Evaluation of Impacts of the HORB Modifications Proposed For The CWF

The South Delta Water Agency Parties

Part 1. Rebuttal Case

Figure 2 Stage Difference Plot for Site: HORB-1

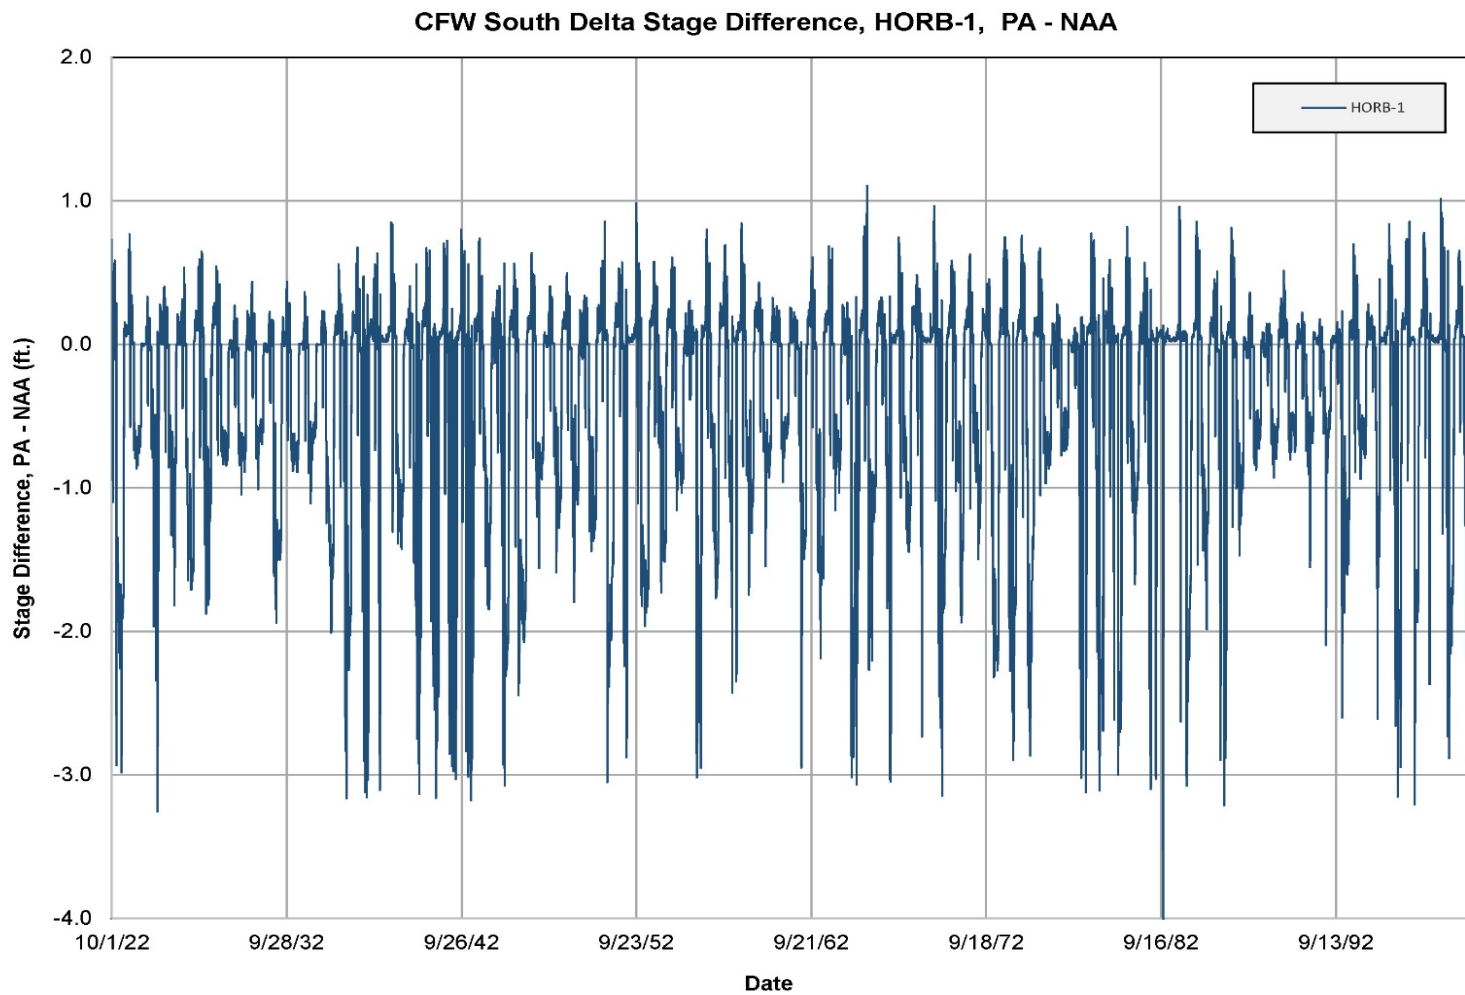
Figure 2 is a plot of the difference in minimum daily stage between the PA and the NAA at Site No. 1. The difference in stage is computed by subtracting the NAA stage from the stage for the PA. As such, a negative difference represents a reduction in channel depth that would result from the CWF PA. As can be seen in the figure, there is a significant amount of time over that 82 year period where the difference is negative. Figure 3 is a blow up of Figure 2, showing the difference in river stage for the 1992 and 1993 water years, which represent a dry and an average water year. This figure is typical of most years and provides more information than Figure 2 for the timing of the stage reduction over the year.

Figure 4 Stage Difference Probability Plot for Site HORB-1

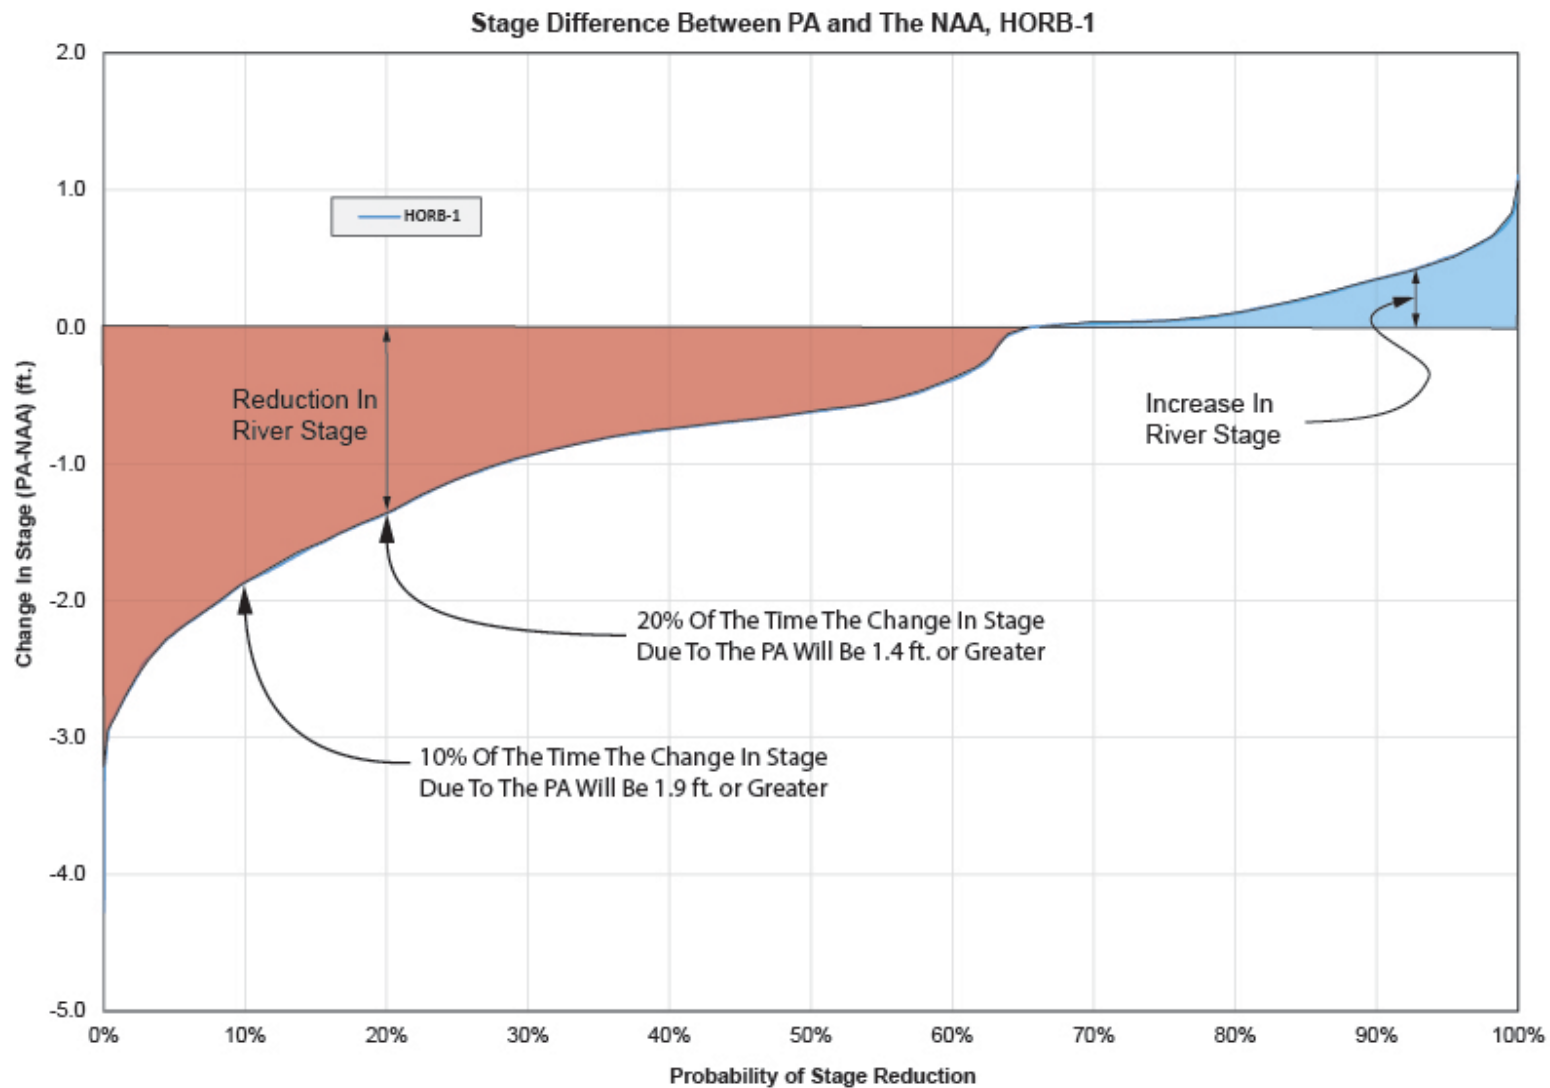
As can be seen in Figure 4, the stage at this location, could be reduced by as much as 3 feet, although that would not be a common occurrence. A more likely analysis of the impact would be to view the stage reduction that would occur 10 or 20 percent of the time. Looking at the plot, it is evident that the stage would be reduced 1.4 feet or more over 20 percent of the time. Over 10 percent of the time, the stage would be reduced 1.9 feet or more. There are times when the stage will increase due to the CWF, but as can be seen by the plot, that will occur much less often, and for not as great a magnitude. The area under the probability curve provides a relative view of the amount of time that the stage would be lowered at this site vs the amount of time that it would increase. The area colored in red shows the percent of time and magnitude of the stage reduction due to the HORB as implemented in the PA. The area colored in blue shows the magnitude and frequency that the stage would increase due to the HORB as implemented in the PA. Similar stage difference plots and stage difference probability curves are provided for the other sites and are included in Appendix C.

Figure 10 Middle River Profile of Channel Invert and Minimum Daily Stage for the PA and NAA of the CWF

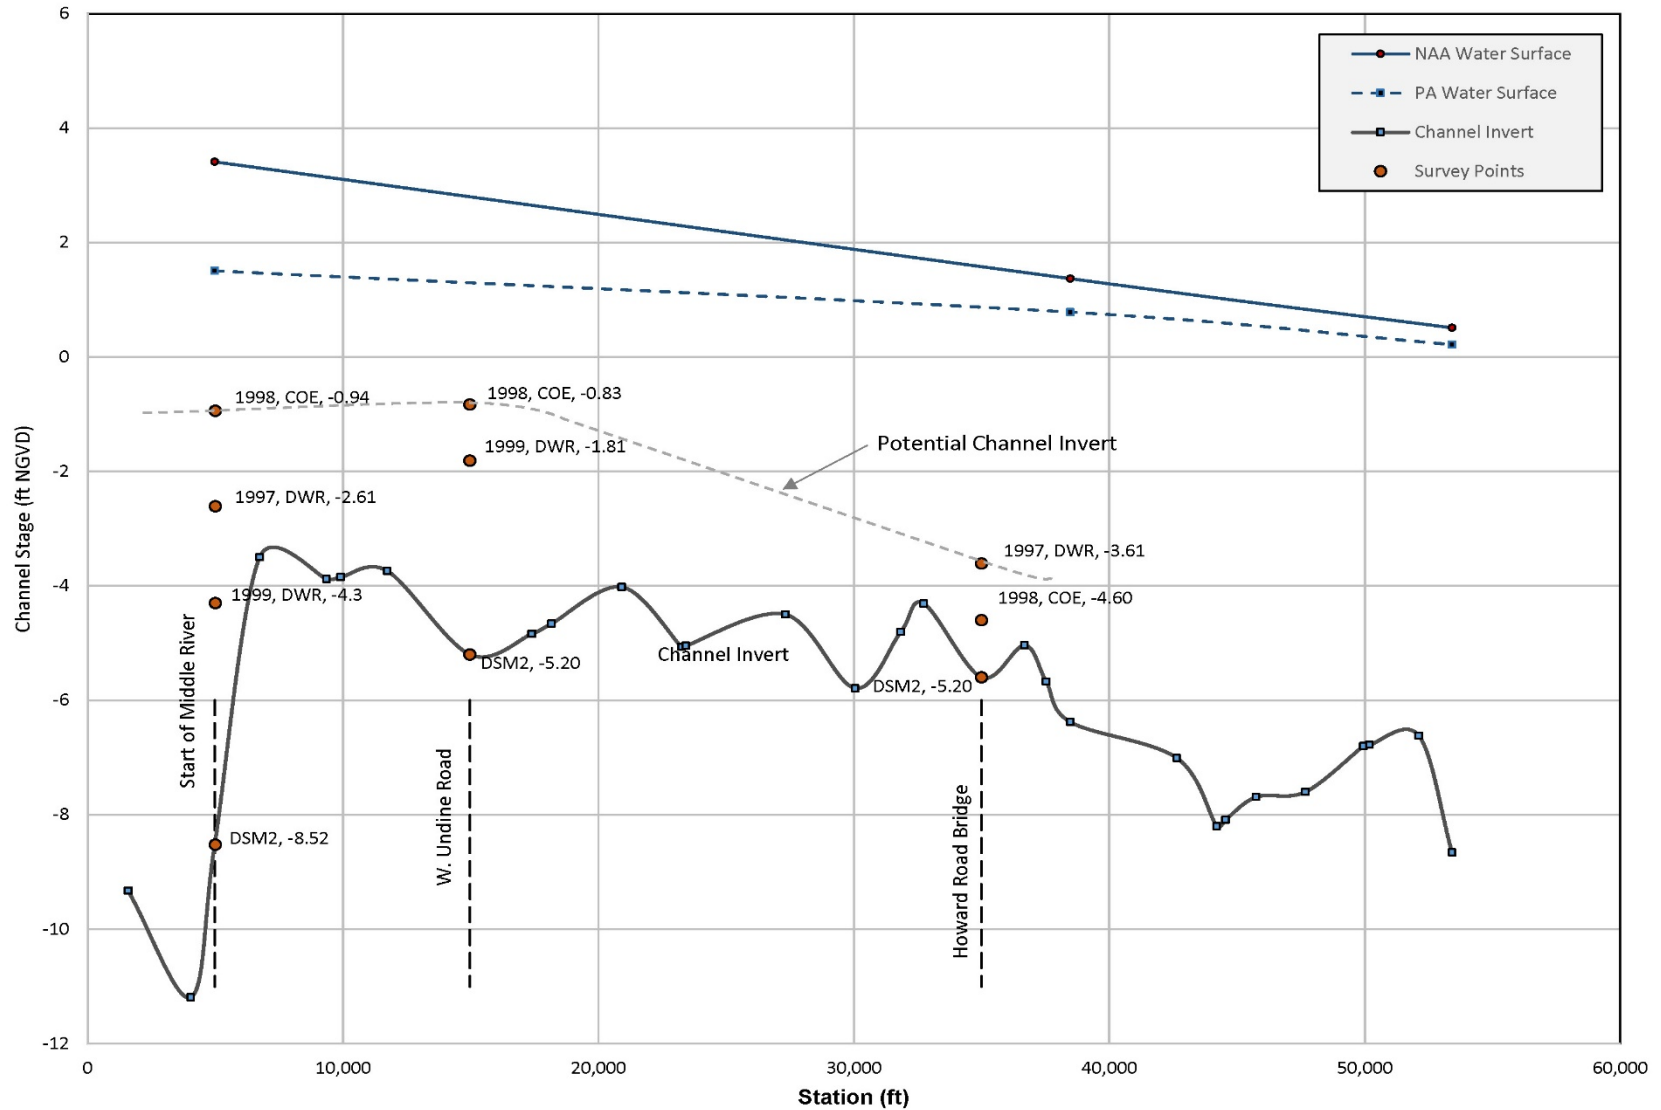
As can be seen in the graph, there is a considerable difference in elevation between the red dots which represent the different survey points and the solid black line that represents the elevation that is used in the DSM2 model. No dredging activities have been conducted in this area since the 1990's surveys were conducted, so it is likely that additional siltation may have occurred since these surveys were completed. The effect of these higher channel invert elevations, is that the depth of water in the channel is decreasing, making it harder to conduct reliable irrigation operations.

Also plotted on Figure 10 is the water surface profiles from the two DSM2 models that represent NAA and the PA. These profiles show the minimum water surface elevation that was simulated for May 23, 1996 in each model. This day was selected to show the reduction in minimum stage resulting from the new HORB operations of the CWF. The water surface profile for the NAA is plotted as a solid blue line. The water surface profile for the PA is plotted as a dashed blue line. The difference between these two lines is the reduction in minimum water stage in the Middle River on this day.

As evidenced in the plot, the *reduction* in minimum water surface elevation, computed as the difference between the PA and NAA water surface elevations at Undine Road is approximately 1.5 feet. Given the 5.2 ft. channel invert used in the DSM2 model, this 1.5 ft. reduction represents about 19% of the total depth of 8 feet. However, if the channel invert is accurately reflected by the survey data collected in the channel in 1998, a 1.5 ft. decrease represents approximately 39% reduction in water depth of the 3.8 ft. of water available under the NAA water surface elevation. By any measure this would encompass a large percentage of the available channel depth.

The channel photos shown in Figures 6 through 8 were taken near Undine Road. As can be seen in these photographs, it is likely that the 3.8 feet of water depth, that should be present from even the highest of the channel survey elevations, is not present. It is likely that additional siltation has occurred since these survey points were collected, making the situation even worse than the worst case scenario in Figure 10 presents.

Figure 15 Percent Reduction in Downstream Flushing Flow and Frequency of Occurrence for Site No. 2.

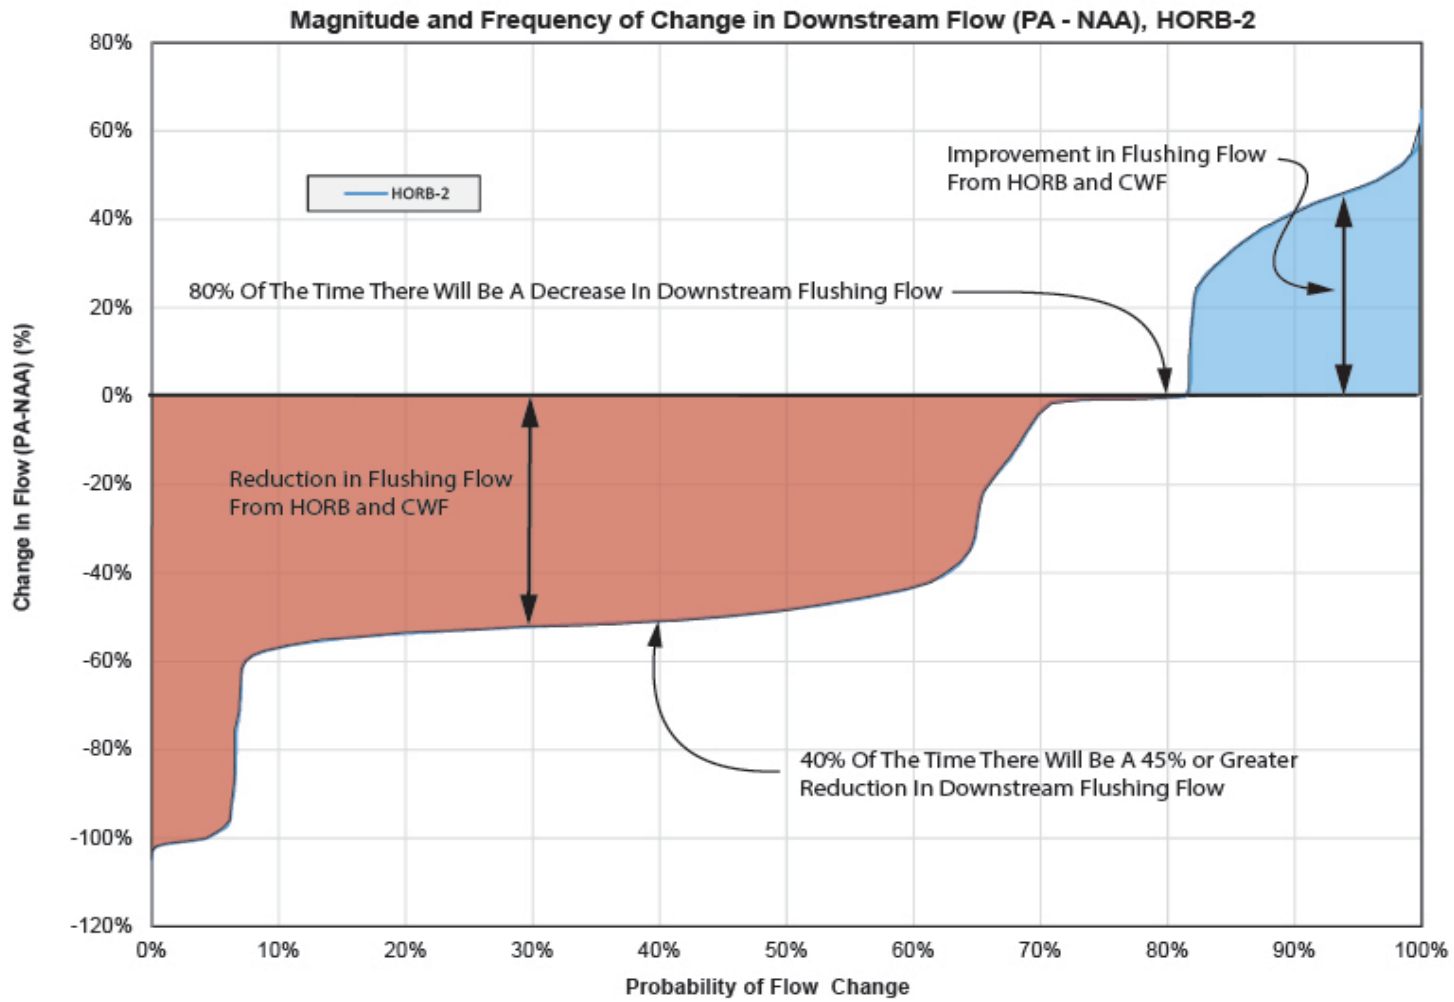
To evaluate the magnitude of the change in flow and the frequency of same, a frequency analysis was conducted of the daily flow change. The data used in the frequency analysis includes only days when the HORB was in place. This allows for a better representation of the impacts due to the HORB. The result of that analysis for Site No. 2 is shown in Figure 15. This figure shows the percent of time that the flow would be reduced by a specific percentage. Plots for additional sites have been provided in Appendix D.

Based on the analysis of the flow change between the two model scenarios, the percent reduction that would occur 10%, 20%, and 50% of the time was computed for all of the sites. That percent reduction in flow is shown in Table 5. As an example, for Site No. 2, 10 percent of the time, there would be a 57 percent reduction in positive flushing flow at this location. Twenty percent of the time there would be a 54 percent reduction in flushing flow at the site, and 50 percent of the time there would be a 48 percent reduction in flushing flow at the site.
